NOTICE OF DECISION

Concept Design Review – New 46-Unit Multi-Family Residential Development

511 S. Oak Knoll Avenue

Case #: DHP2024-00261

GROUND FLOOR PLAN A-1.1

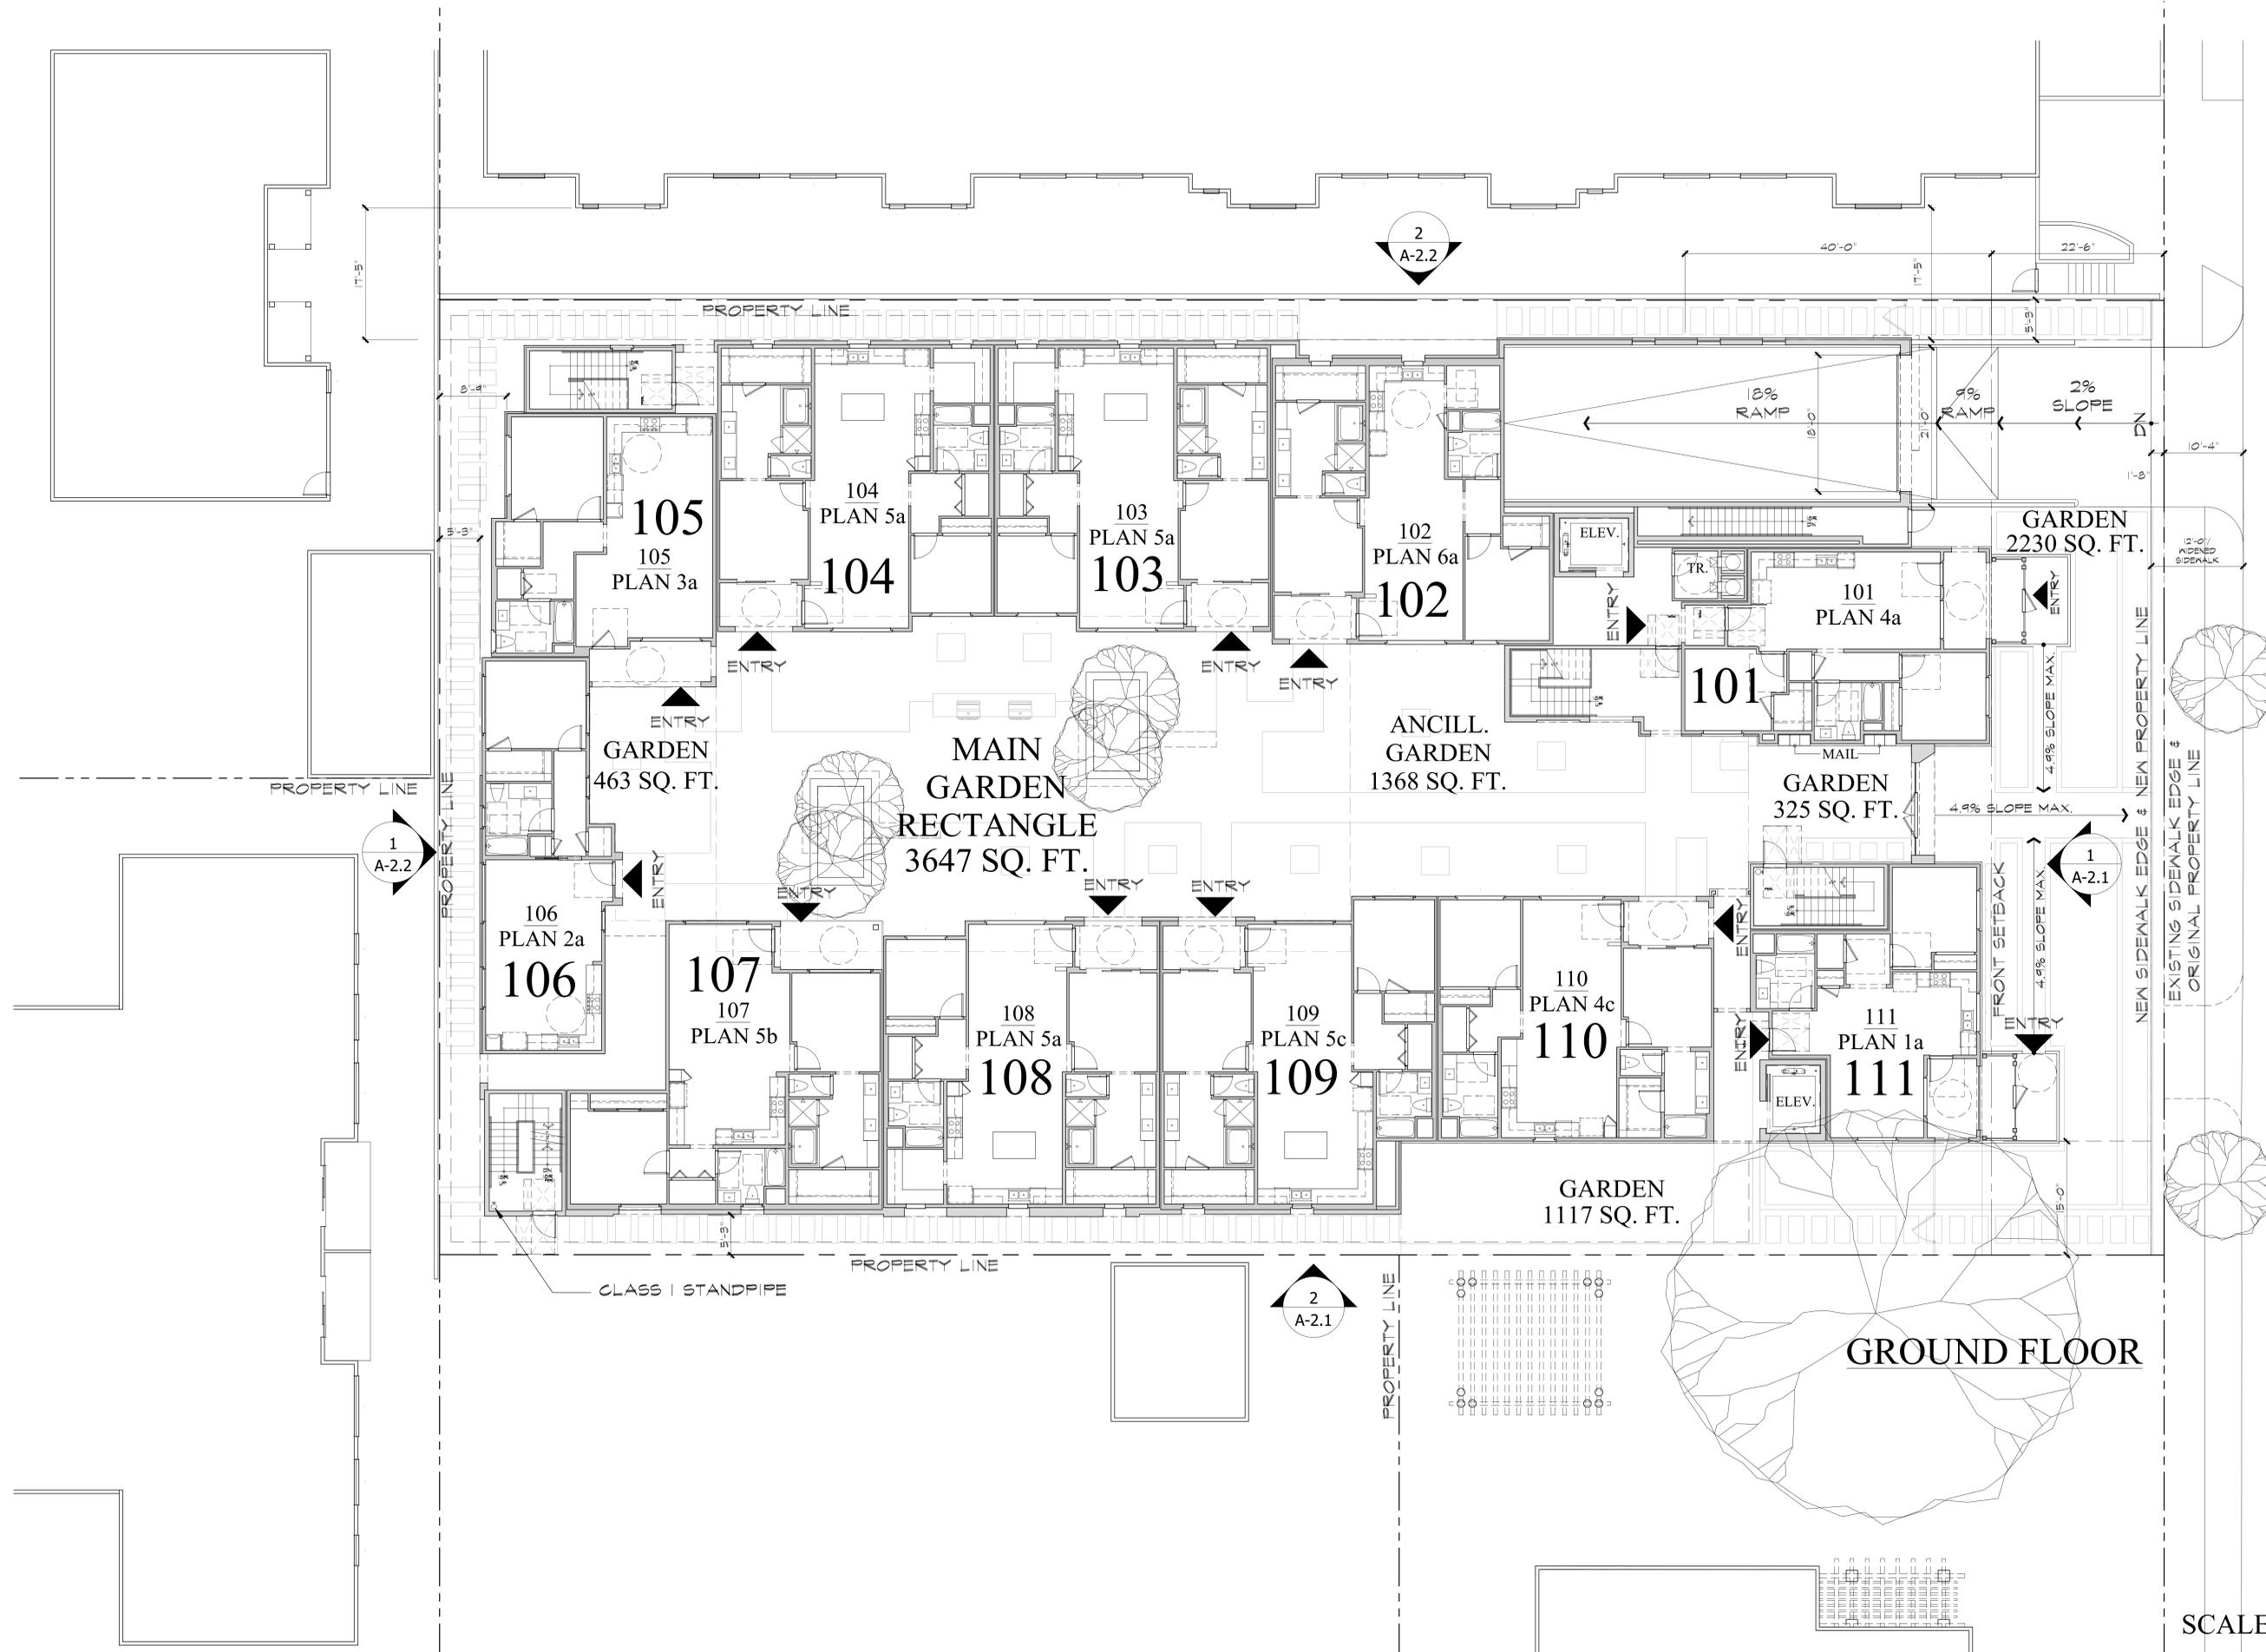
3. Plans submitted for Final Design Review shall include details for the proposed Craftsmanship Feature and Building Elements.
4. A tree protection plan prepared by a Certified Arborist shall be incorporated into the plans submitted for Final Design Review and shall include the City of Pasadena Tree Protection Guidelines dated 5/13/19 (see Attachment G). The tree, which shall be protected, is tree number OP1 as shown in the ground floor plan included in Attachment B.

1. EAST ELEVATION

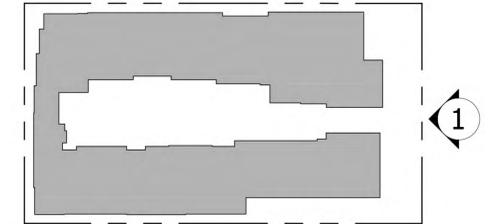
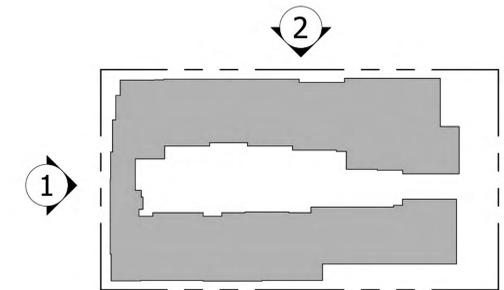
1. Study and refine the integration of the mansard roof forms into the building massing and the application of the proposed brick material (both height and extent) at the front of the building. The brick base material shall be utilized consistently along the entire front façade at a consistent height throughout and shall wrap to the easternmost portion of the north elevation. Study the brick archway feature further to align with the height of the brick on the façade and to review its proportions/thickness in relation to the building overall.

2. Study the treatments and features at the north, south and west elevations and incorporate similar treatments as the front façade, including solid-to-void proportions and bay window features.
